SURVEY FOR
U.S. FOREST SERVICE

SMITH-UMP CADASTRAL
CONTRACT NO. 53-04TO-3-0935N
SECTION 26, T21S, R11W, W.M.

DOUGLAS COUNTY, OREGON

FEBRUARY 24, 1984

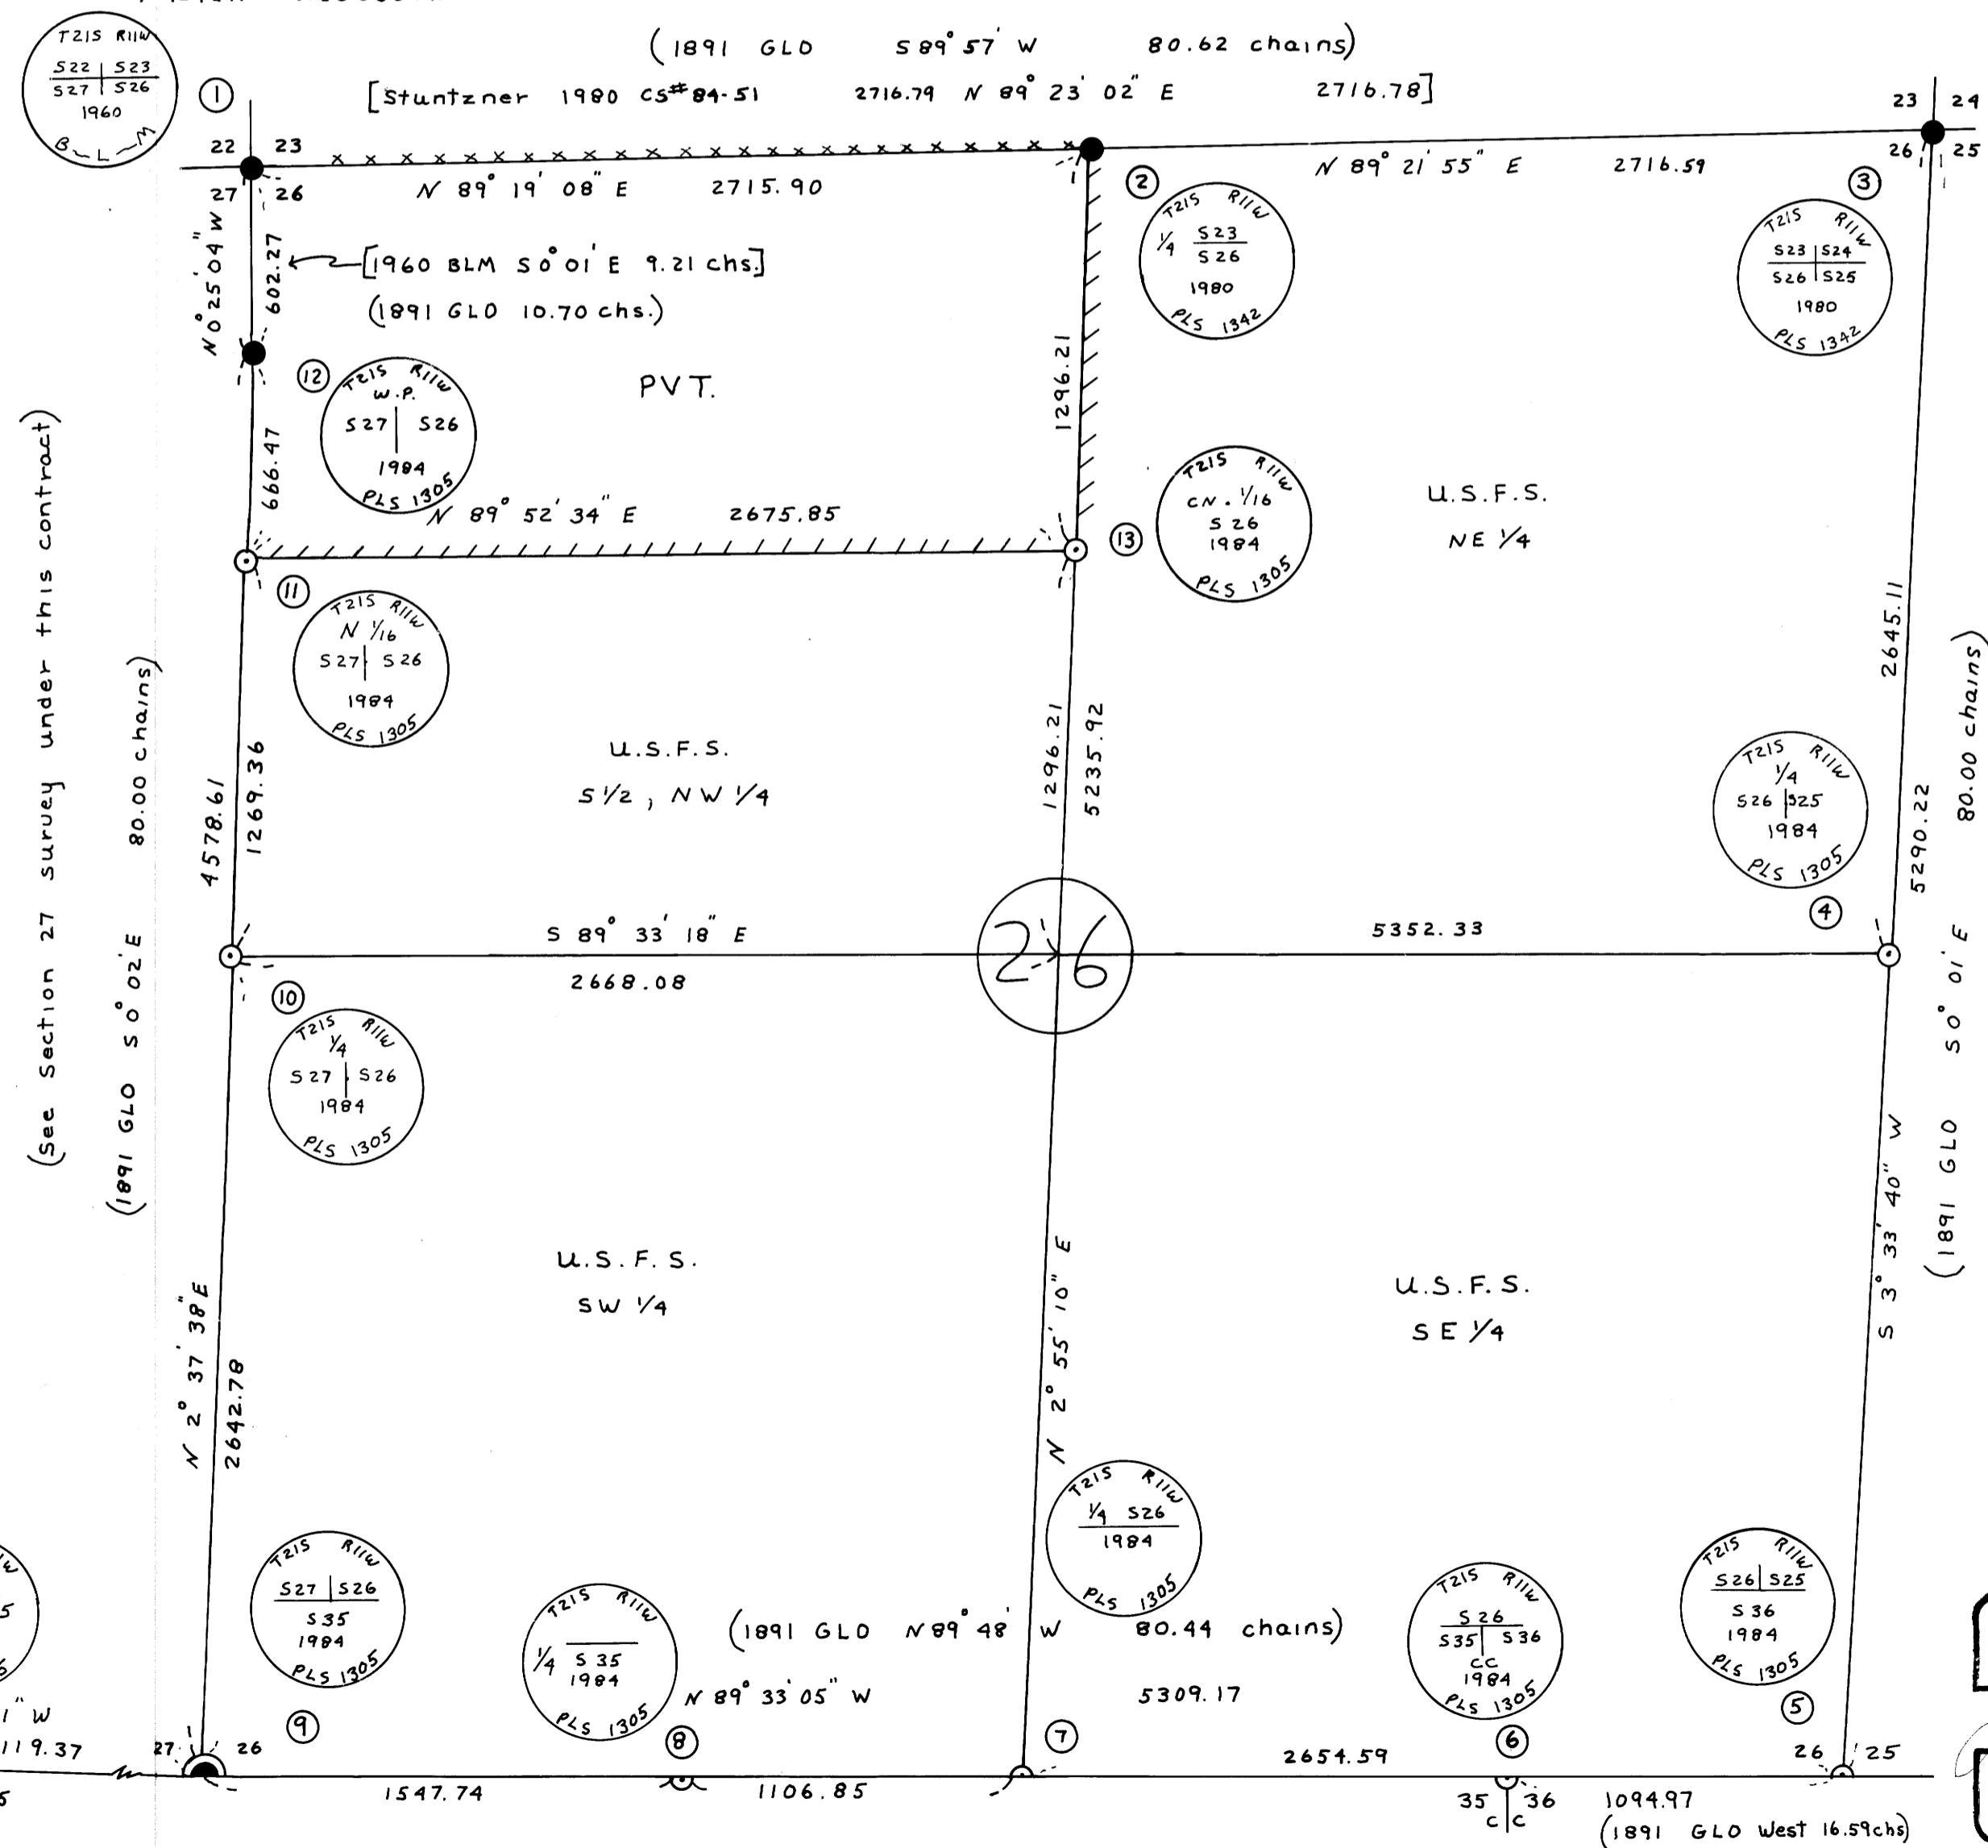
Based on the ground conditions you have developed, your submitted material contains several proposed methods, including the 1974 BLM recommendation, all of which indicate some distortion in bearings and/or distances from the original record. The 1974 BLM recommendation (your method No. 1) creates what we consider to be minor distortion in bearing but produces distances that in most cases are closer to matching the record than the alternatives; i.e., some bearing distortion gives way to generally good distance relationships.

After examining all possible methods that you have proposed, it appears that no one method can be adopted that will not create some distortion. Considering this, we feel the factor that should determine the method used is that which would normally be called for in such instances, according to the BLM Manual and common practice. Therefore, it is our opinion that the procedures outlined to Mr. Ingram in 1974, and reiterated in your letter, are still valid and would probably be used by this office if we were conducting the survey.

With regard to the monument at the $\frac{1}{4}$ section corner of sections 21 and 28 which the BLM reestablished in 1960, and you found to be approximately 25 feet from its proper position, we feel it should remain as is. This decision is based on (1) its length of existence, (2) the fact that its position was used by a 1977 private survey, and (3) its position does not constitute what we consider to be gross error.

The problem you have posed is not to calculate the position for the southeast corner of section 34, but rather to restore the meander corner of sections 34 and 35. The point for the section corner mentioned in Byars' record falls in a meandered river and hence does not exist either in theory or practice.

The Manual (Section 5-40) prescribes that meander corners on lines projected across meandered bodies of water will usually be reestablished by single proportionate measurement (occasionally, by single point control), or in extreme cases, by adjustment of the record meanders. It also allows for special cases (Section 5-46) where the surveyor's experience and judgment may properly override or modify these principles.

In our opinion, the meander corner of sections 34 and 35 should, in this case, be reestablished at record bearing, South, from the original $\frac{1}{4}$ section corner of sections 34 and 35, and at record distance, 17.89 chains, from the $\frac{1}{4}$ section corner if this distance places the meander corner on or very near the present meander line. If the record distance falls close, but not on the meander line, the present shoreline may be treated "as an identified natural feature" (Section 5-40) and the meander corner reestablished on it.

There are many potential pitfalls in using control south of the river to restore the meander corner in question. You refer to some of these in your letter. Whenever possible, survey errors or discrepancies should be isolated where they "properly belong" (Section 5-23) and should not effect proportioning of lost corners beyond their immediate area. In line with this principle, projecting Byars' survey across the river through his 23.22 chain triangulation would probably introduce more error than using his 17.89 chain tie to the $\frac{1}{4}$ section corner.

In addition, it makes little sense to extend possible distortion from questionable corners, which are 74 to 96 chains away, across a river, and in another township, when the original $\frac{1}{4}$ section corner of sections 34 and 35 is much closer, probably more reliable, and in the same township. While certain aspects of Haines' work are debatable, it is not necessary to pass judgment on his survey one way or another, as the method we suggest for restoring the meander corner ignores his survey and conforms to the Manual.

A second best solution might be to reestablish the meander corner by single proportionate measurement between the corner of sections 3 and 10, T. 22 S., R. 11 W., and the $\frac{1}{4}$ section corner of sections 34 and 35, since these two seem generally accepted as original corners. From your data, it appears that such a restoration would place the meander corner about 8 links south and 30 links west of a point at record bearing and distance from the $\frac{1}{4}$ section corner of sections 34 and 35. The two locations are favorably related and tend to confirm one another, but all things considered, a single point control restoration is preferable.
